**Highland Township Fire Department
Fire Station No. 1**

**ADDENDUM No. 3
April 30, 2020**

Project Name: Highland Township – Highland Township Fire Station No. 1 Addendum No: Three (3)

Project Number: 18-122A Issue Date: April 30, 2020
Project Location: 1600 W. Highland Rd. Highland, MI 48357

5 Decorative Bracket Detail
1/4" = 1'-0"

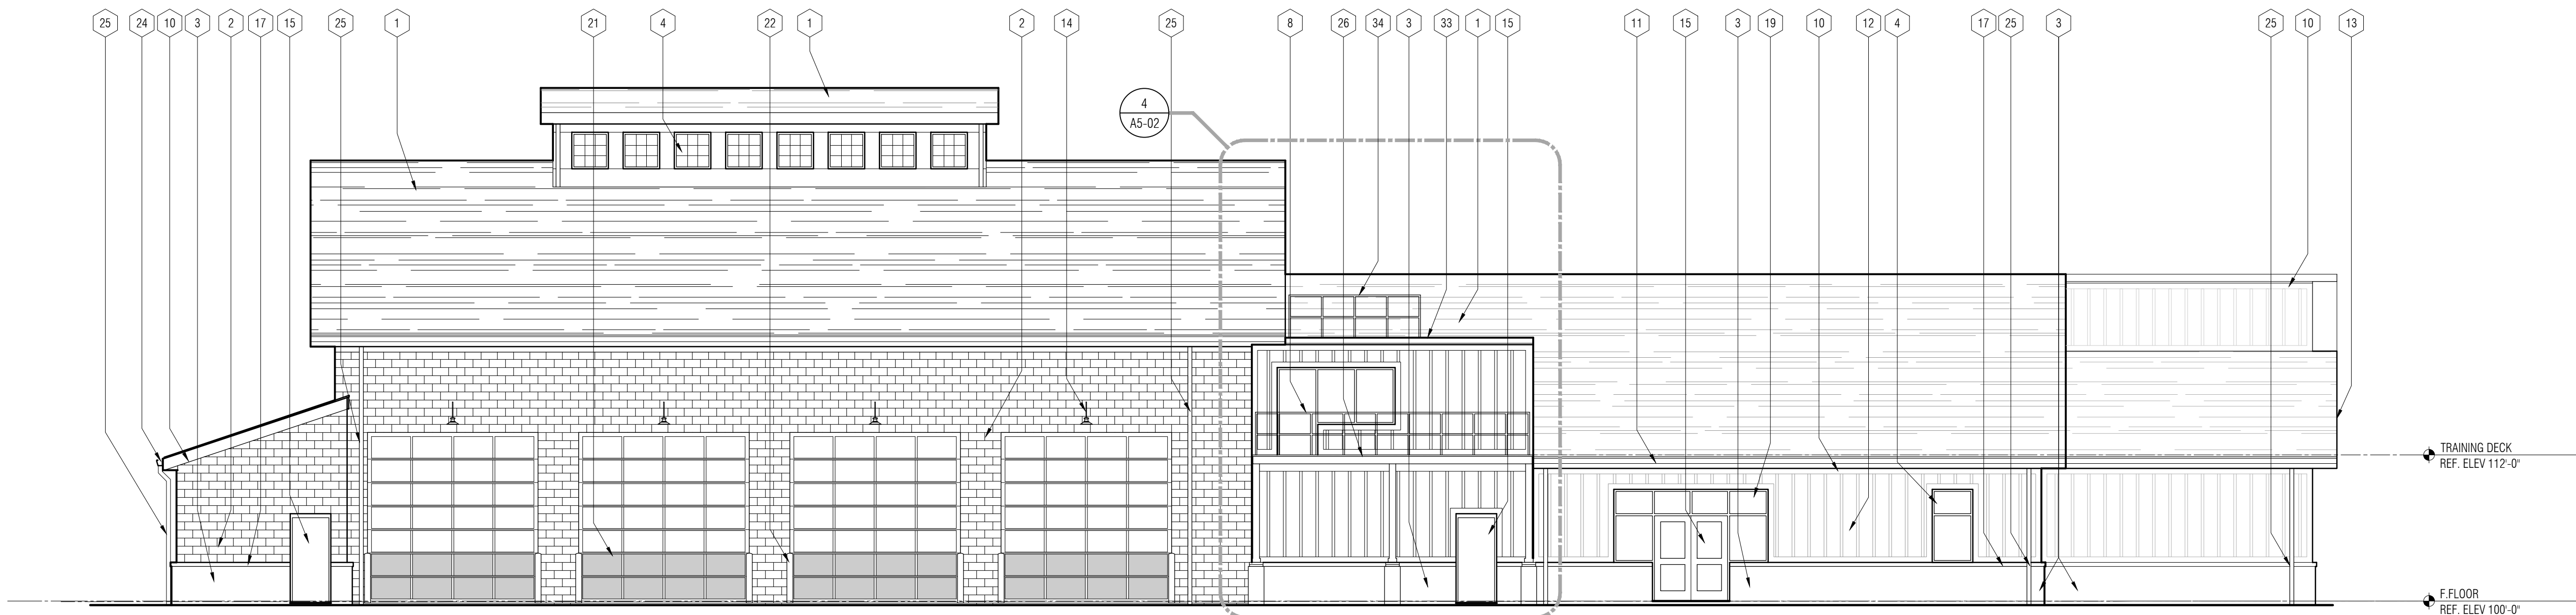
- ITEM A1 A5-01 EXTERIOR ELEVATIONS
A. Add wood bracket detail 5/A5-01.
B. Add and revise wood bracket notes and dimensions.
- ITEM A2 A6-01 WALL SECTION
A. Update Truss and Bracket detail on 2/A6-01.
B. Revise notes

ROOF FRAMING PLAN

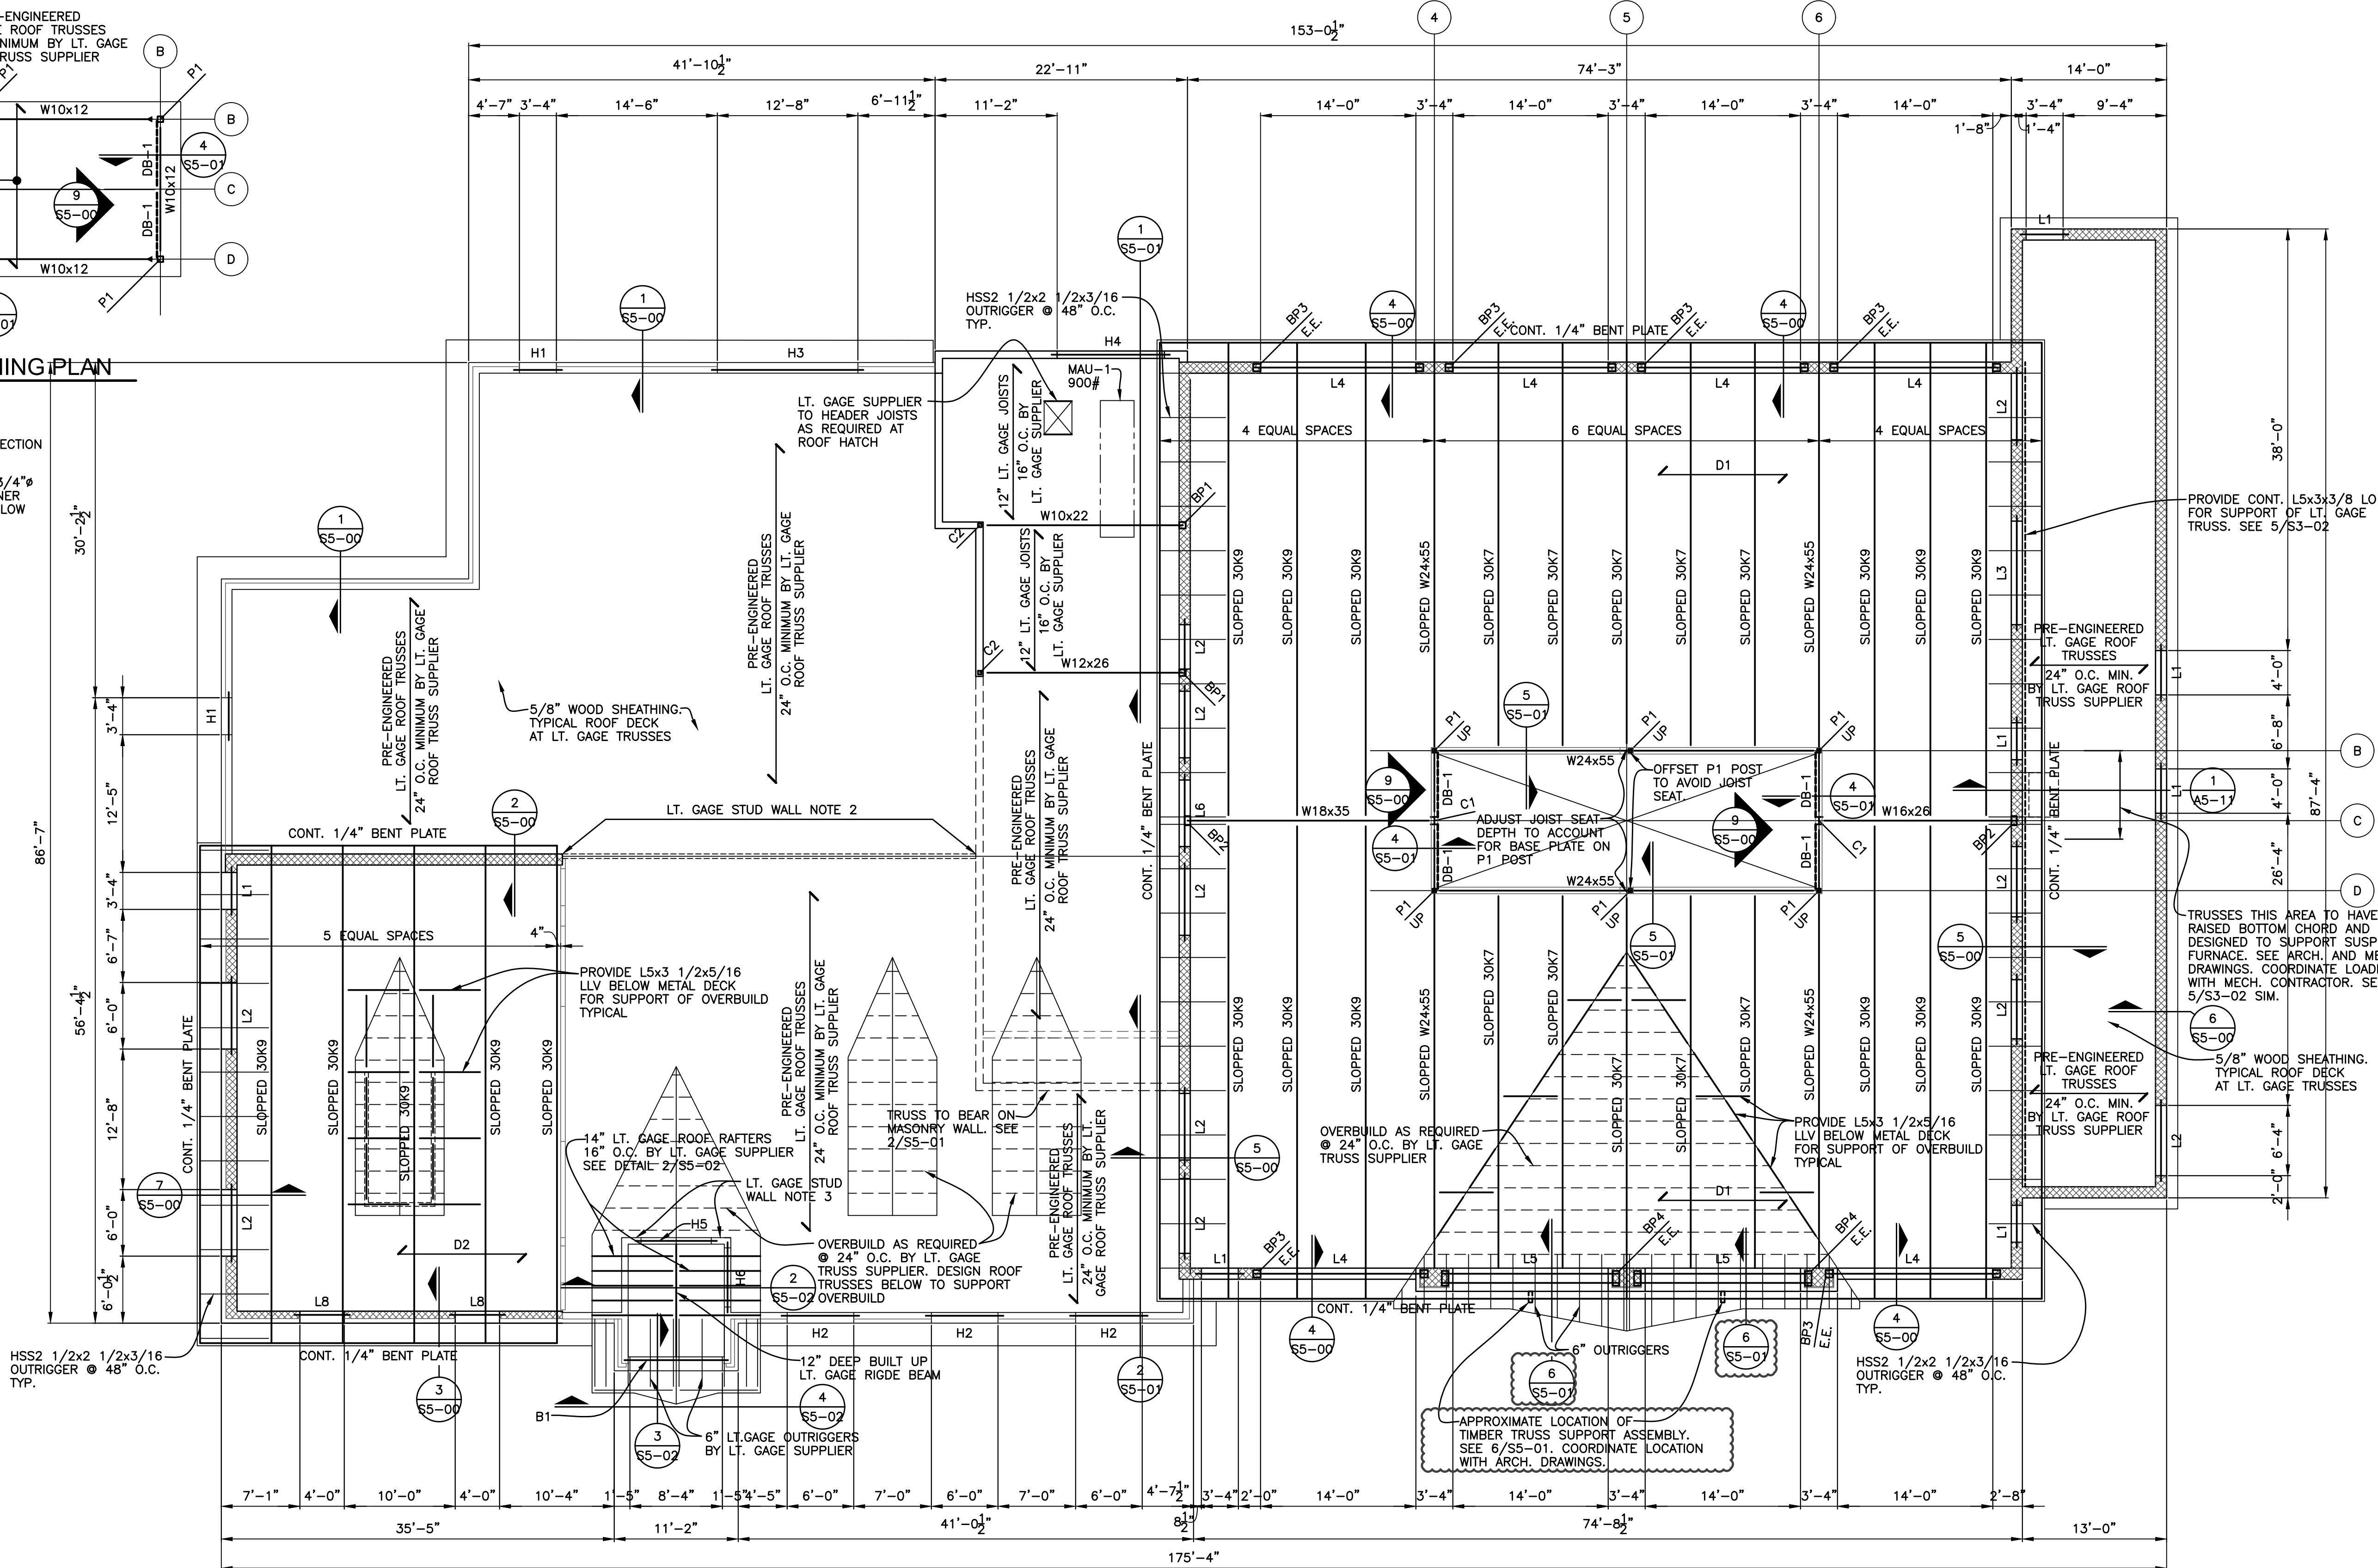
- ITEM S1 S3-03 ROOF FRAMING PLAN
A. Update notes and section 6/A5-01.
- ITEM S2 S5-01 DETAILS
A. Add notes and revise details for truss and bracket on detail 6/A5-01.
